PARKWAY HEIGHTS MIDDLE SCHOOL MODERNIZATION - PHASE II PROJECT 01-18

Addendum 01

FEBRUARY 15, 2018

ADD 01
01.03

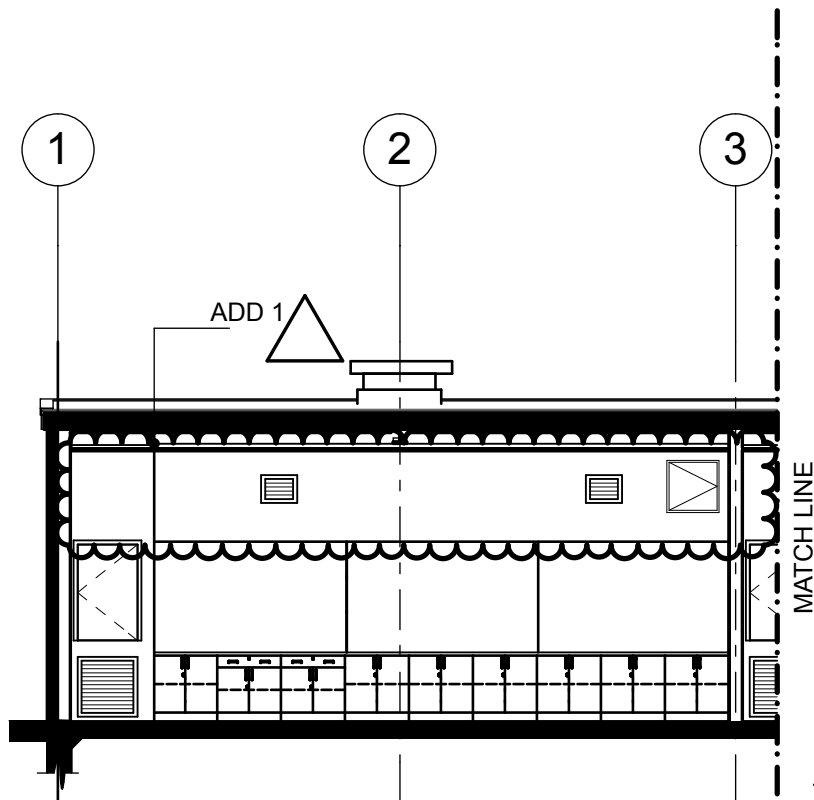
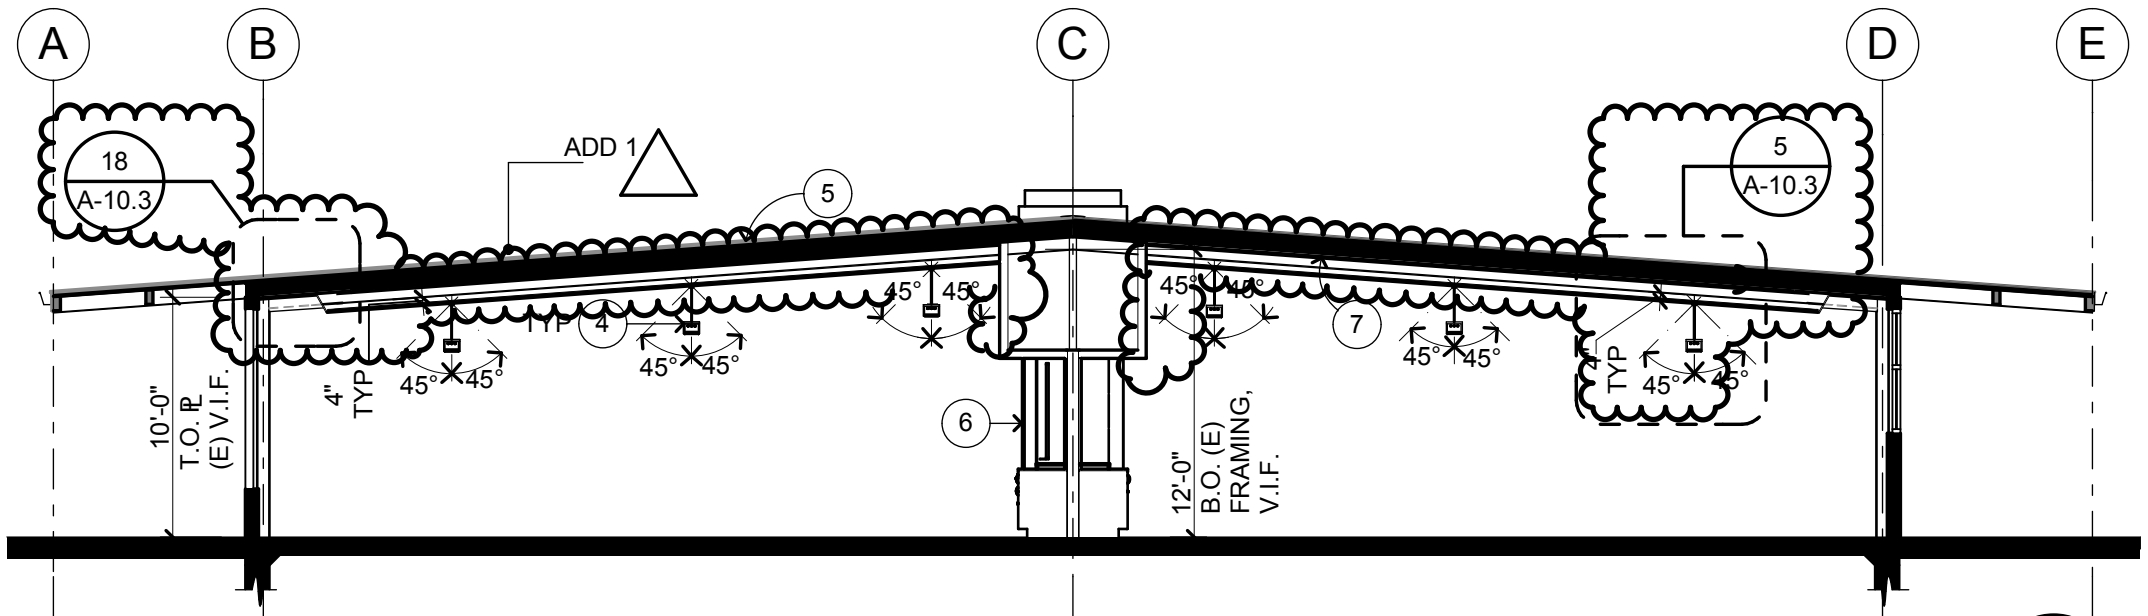
Sheet A-6.1 - BUILDING SECTIONS
Suspended Acoustical Ceiling added to sections. See Add 01.03

ADD 01
01.04

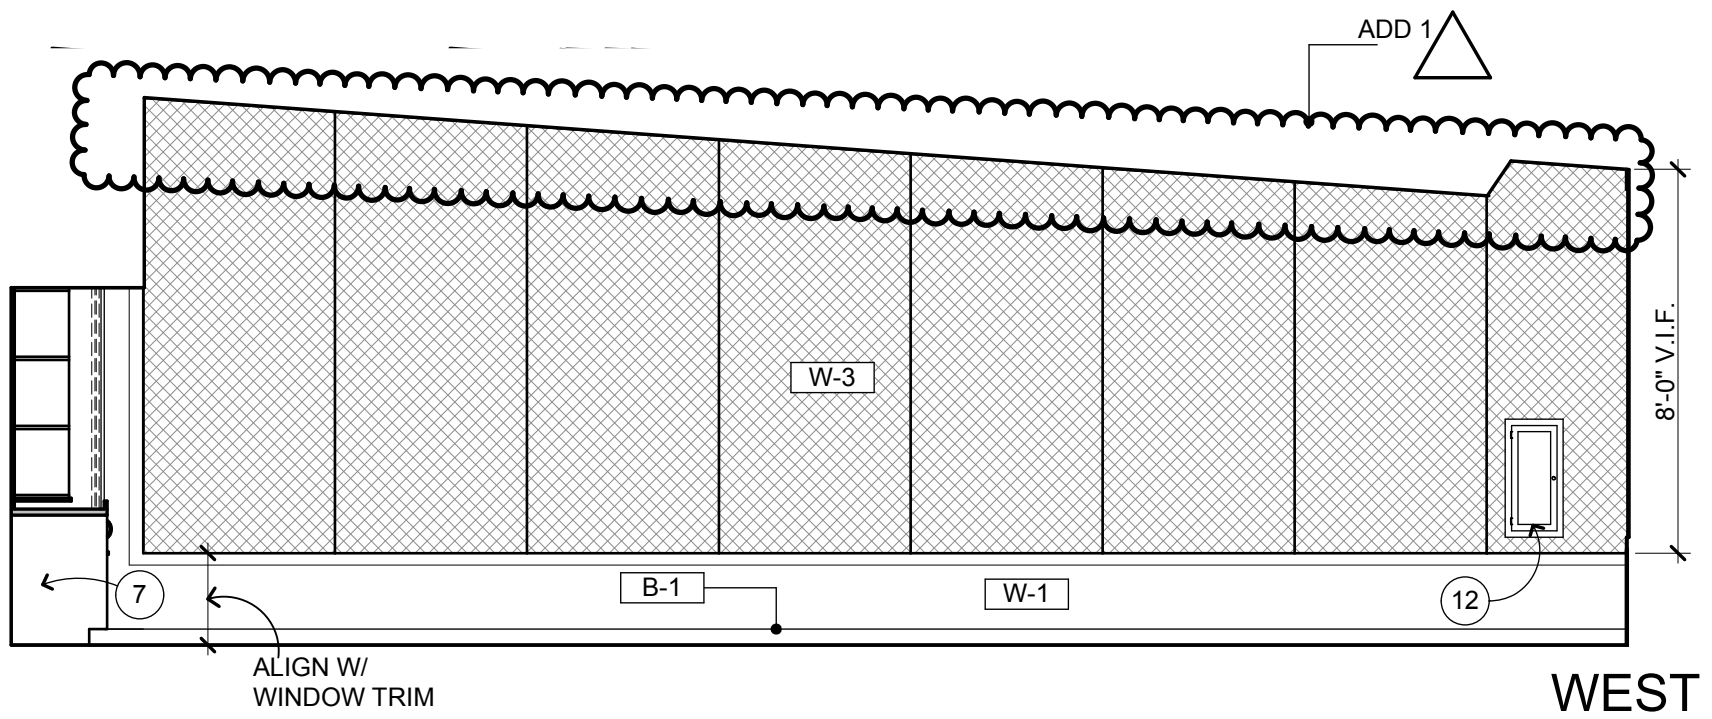
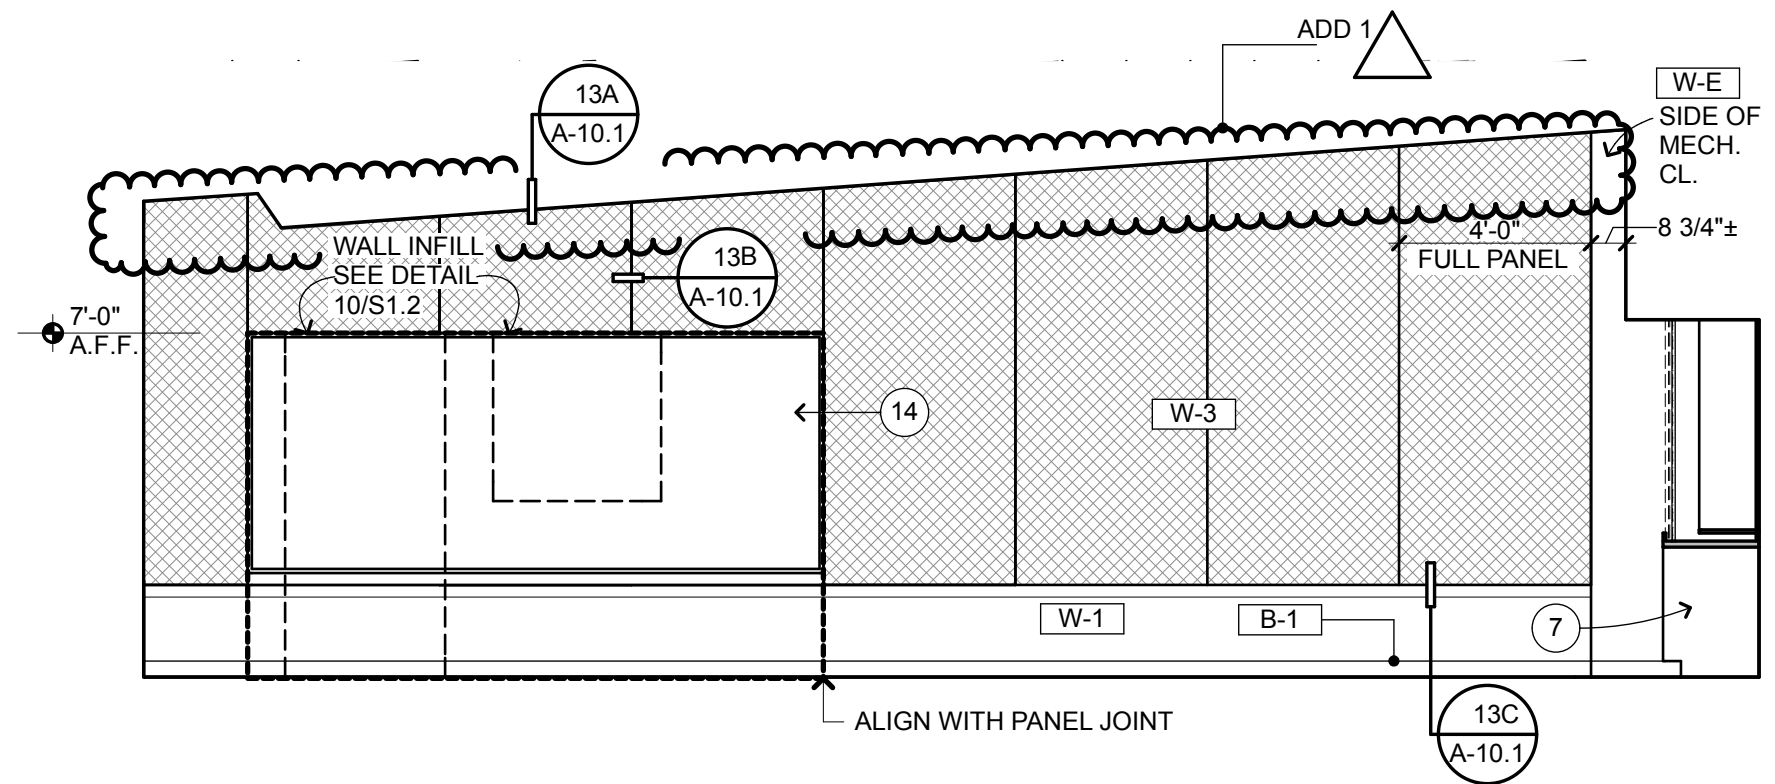
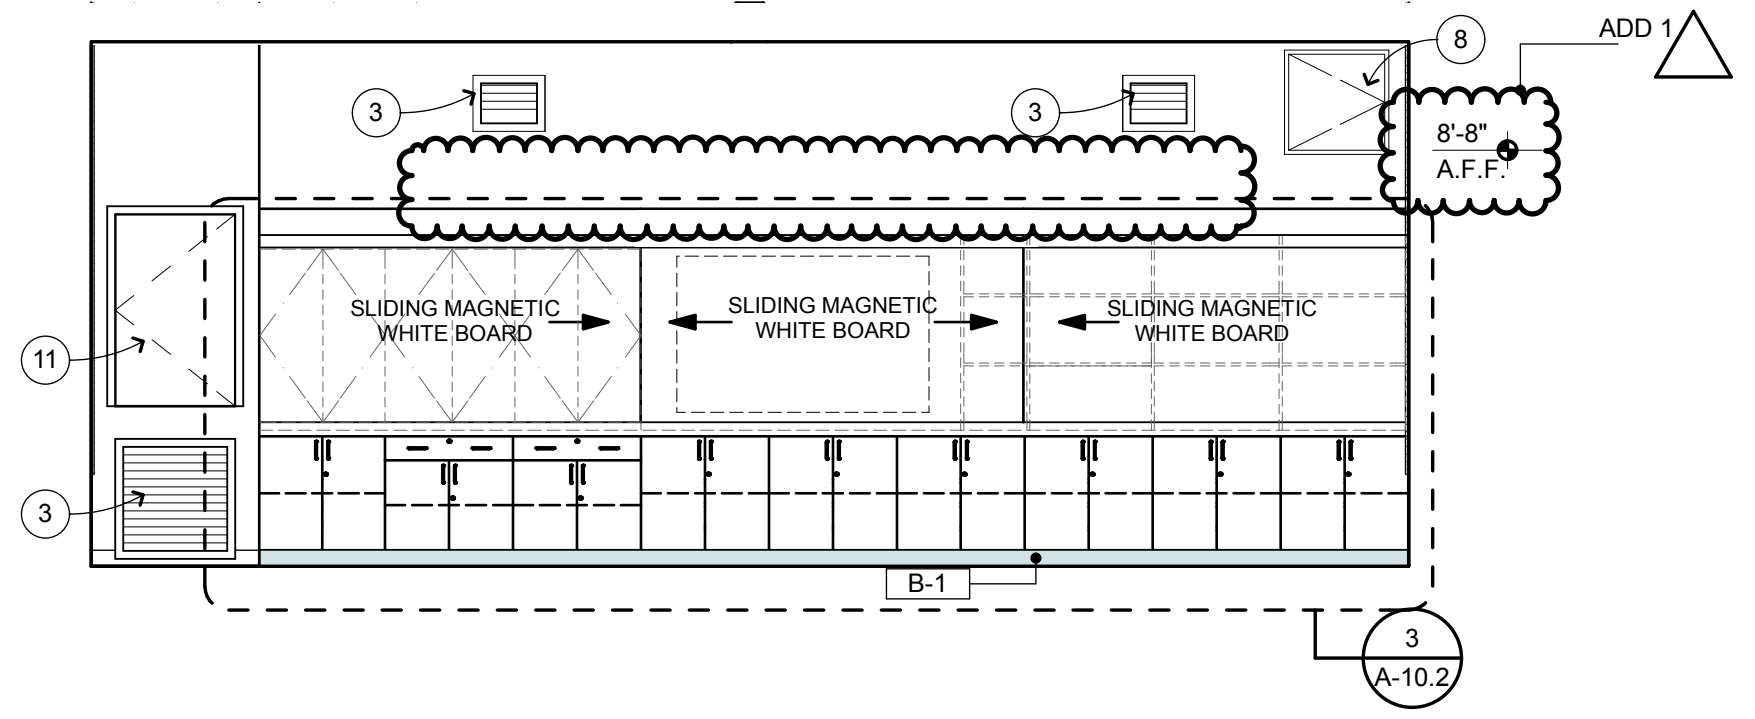
Sheet A-7.1 - A-7.4 INTERIOR ELEVATIONS
Ceiling lowered to accommodate for suspended ceiling. Typ. at classrooms. See Add 01.04

Sheet A-7.1 - A-7.4 INTERIOR ELEVATIONS
Remove all wall mounted light fixtures above teaching walls. Typ. at classrooms. See Add 01.04

ADD 01
01.06

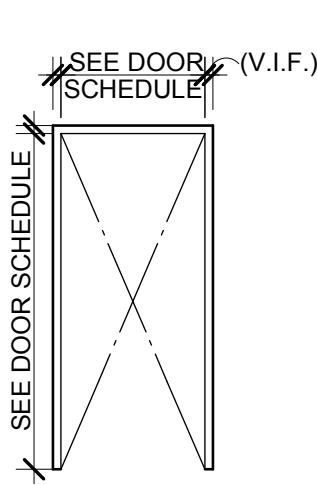
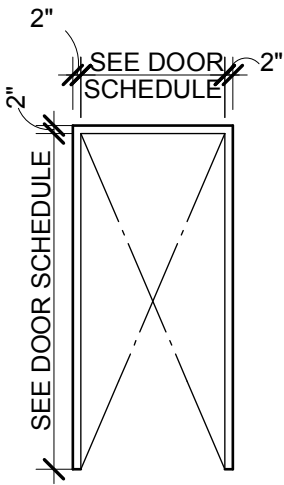
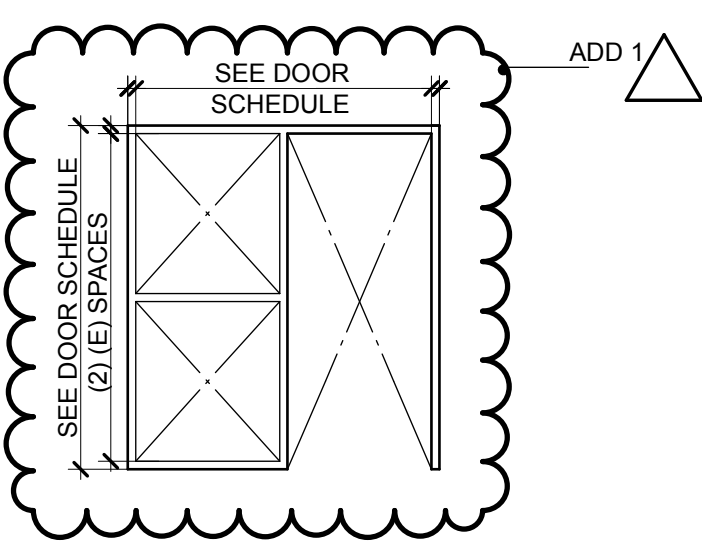
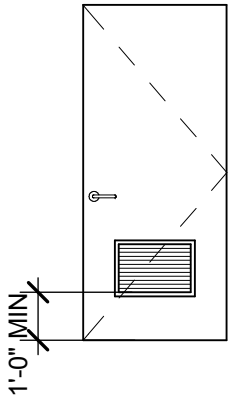
Sheet A-8.1 - DOOR AND WINDOW SCHEDULE
Infill at restrooms doors to be existing and painted, eliminate obscured glass. See Add 01.06

ADD 01
01.07

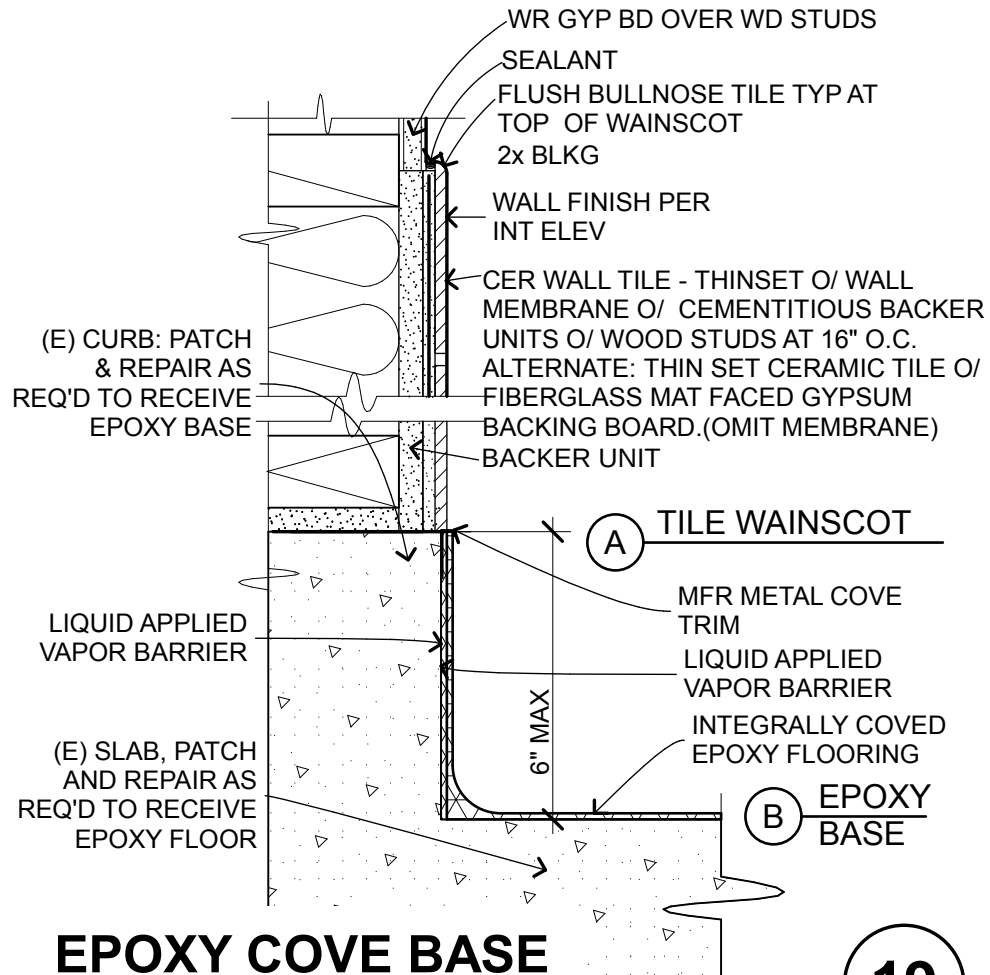
Sheet A-2.1 - FLOOR PLAN
Revise Finish Code F-2 to Epoxy Flooring. All floor tile to be deleted from project. See ADD 01.07

Sheet A-10.1 - INTERIOR DETAILS
Detail 3 modified to show epoxy flooring and epoxy base. See Add 01.07

ADD 01
01.08

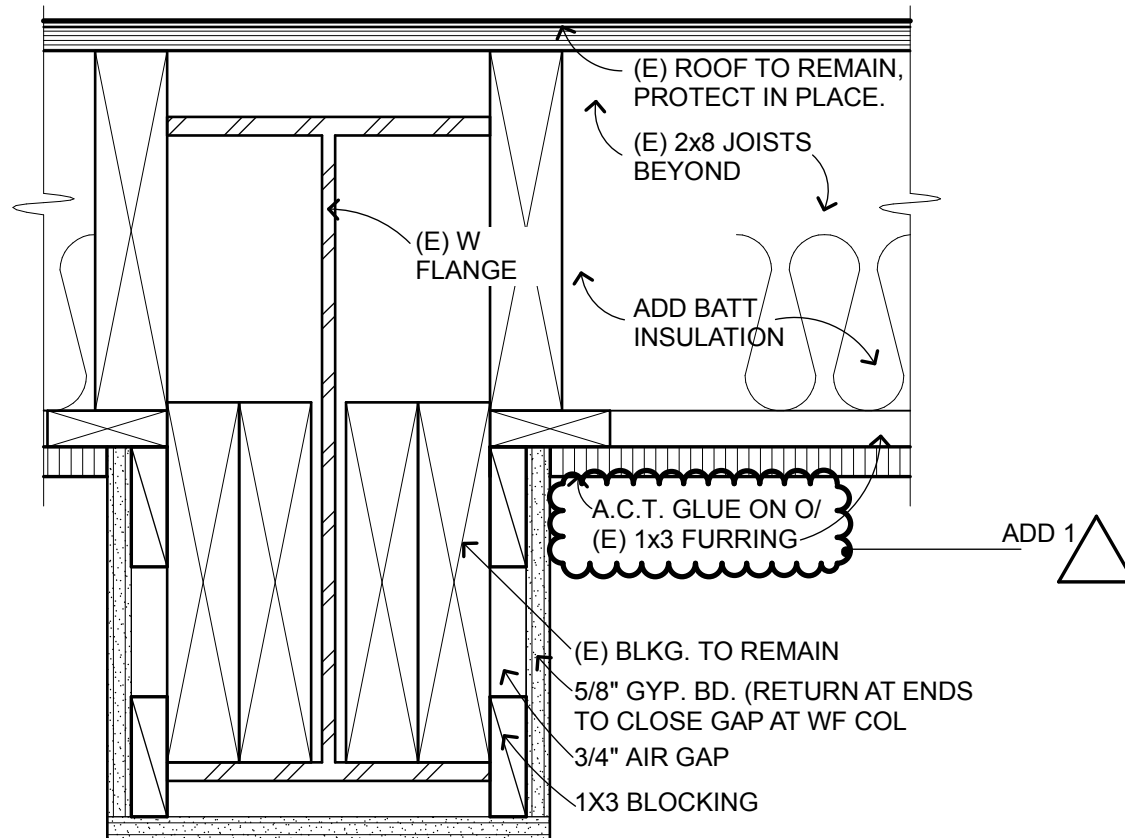
Sheet A-10.1 - INTERIOR DETAILS
Detail 2 (BEAM DETAIL) revised. See Add 01.08
